Access Compliance Report

Public Rights-of-Way

(Curb Ramps)

Intersection ID: 14547	Main Street: EAST_BV	Cross Street: SPRINGDALE_AV	Location: NE
ADA ID: 27AA467A725F	Ramp Type: Perp	Initial Pass/Fail: Fail	Overall Compliance: No
Codes/Mitigation Info/Possible Solution		Field Measurements/Component Compliance	
Severity Score: 13.75

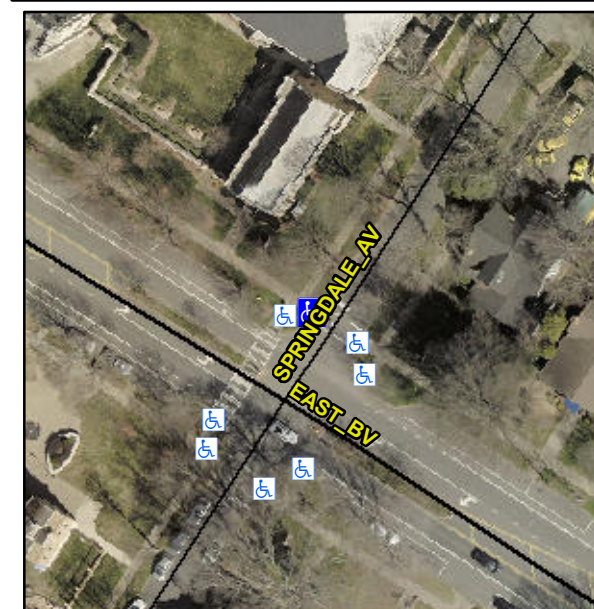
Not Found, R304.2.2, R304.5.3

Compliance	Description	Data	Compliance	Description	Data
N/A	Ramp Length (in)	74.0	No	Ramp Slope (%)	9.7
Yes	Ramp Width (in)	72.0	No	Ramp XSlope (%)	3.5
N/A	Flare Type LT	N/A	N/A	Flare Type RT	N/A
N/A	Flare Slope LT (%)	N/A	N/A	Flare Slope RT (%)	N/A
N/A	Flare Traversable LT?	N/A	N/A	Flare Traversable RT?	N/A
N/A	Landing Length (in)	N/A	N/A	DWS Provided?	N/A
N/A	Landing Width (in)	N/A	N/A	DWS Contrast?	N/A
N/A	Landing Slope (%)	N/A	N/A	DWS Length (in)	N/A
N/A	Landing X Slope (%)	N/A	N/A	DWS Full Width?	N/A
N/A	Landing Curb? (Y/N)	N/A	N/A	DWS Offset (in)	N/A
N/A	Shared Landing?	N/A			
N/A	Gutter Ponding?	N/A	N/A	Gutter Slope (%)	N/A
N/A	Gutter Lip Ht (in)	N/A	N/A	Gutter X Slope (%)	N/A
N/A	Painted X Walk1?	Yes	N/A	Painted X Walk2?	N/A
	X Walk 1 Direction	To SE		X Walk 2 Direction	N/A
N/A	X Walk 1 Width (in)	110.0	N/A	X Walk 2 Width (in)	N/A
	X Walk 1 Slope (%)	2.1		X Walk 2 Slope (%)	N/A
	X Walk 1 X Slope (%)	1.3		X Walk 2 X Slope (%)	N/A

Remove & Replace Entire Ramp.
